SUBJECT: Replacement of Seat Release Tube Attachment Bolt

MODELS AFFECTED: M20F S/N 670001 thru 670175

FIGURE 1

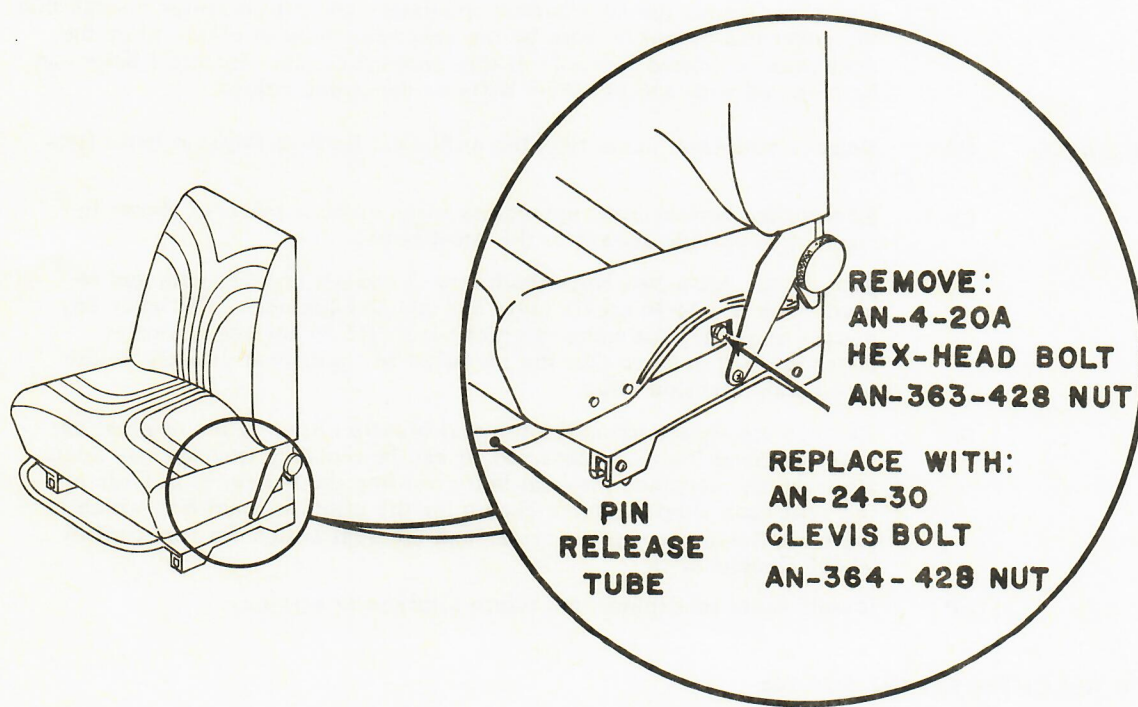
INTRODUCTION: On the aircraft above, the front seat pin release tube is attached on both sides with an AN-4-20A hexagon head bolt. The head of this bolt can sometimes cause the seat bottom upholstery cover to protrude enough that the cover can be cut or worn by the seat back support plates when the seat back is rotated forward. If this problem occurs, the AN-4 bolts can be replaced with AN-24 clevis bolts as described below.

- INSTRUCTIONS:
- (1) Remove both front seats from the airplane. Remove the seat belts from the seats.
 - (2) Remove the bottom cover upholstery clips on both sides as shown in figure 1 to provide access to the AN-4 bolts.

- (3) Remove the AN-4-20A bolts (both sides) and AN 363-428 nuts and replace with AN-24-30 clevis bolts and AN-364-428 nuts. Cut away any canvas material from under the bolt head, and do not use a washer under the bolt head so that the installed bolt will bear directly on the metal web retention strap.

- (4) Replace upholstery using the original plastic clips. If the original upholstery cover has been damaged, it can be replaced from Mooney Spare Parts stock. Replace the seat belts, routing the belt webs outside of the seat back support plates except for the pilots inboard belt which is routed between the support plates and the seat bottom for trim control wheel clearance.
